H265 (HEVC) over 1722 proposal

Presented to 1722 Working Group on 9th June 2020

Kieran Tyrrell - Sienda

Figure 41 - H.265 Compressed Video Format PDU
(edit h264 to h265, the structure is the same)

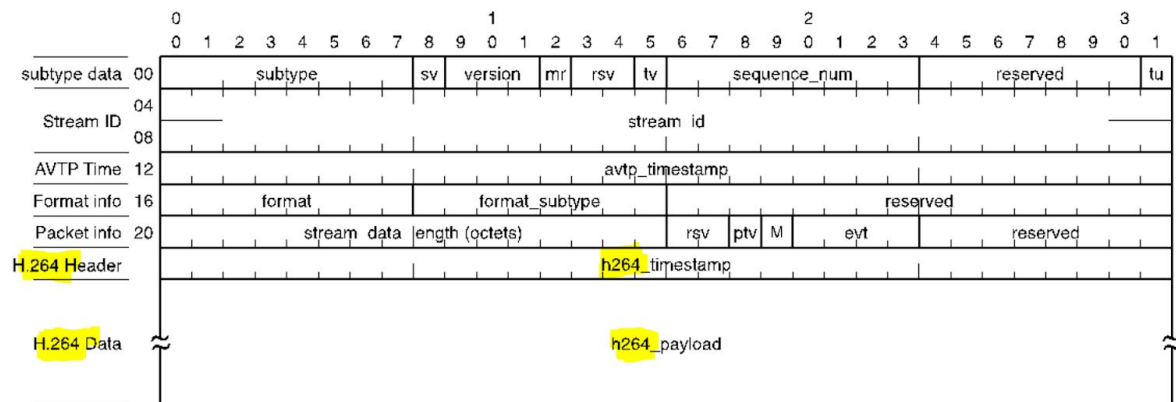
The fields of the [H.265](#) Compressed Video Format are given in Figure [41](#).

Example of an AVTP packet including a single NAL Unit payload (NOTE: a h264 equivalent of this is NOT currently represented in 1722. Do we need this? It is almost a clone of RFC7798 Section 4.4.1 Figure 3.

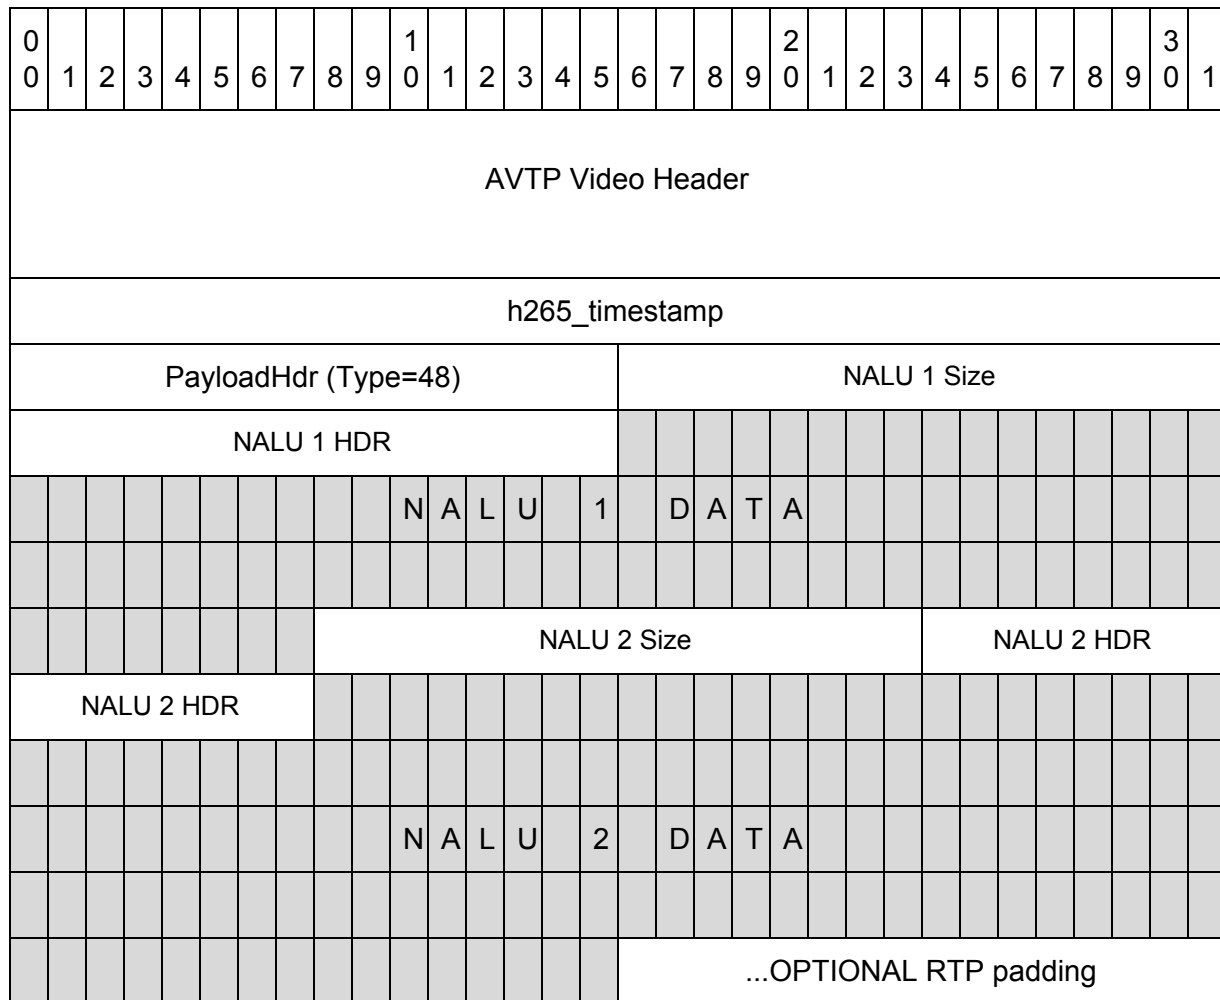
Example of an AVTP packet containing two aggregation units without the DONL and DOND fields (note this is similar to RFC7798 Section 4.4.2 Figure 7 but with AVTP header instead of RTP header)
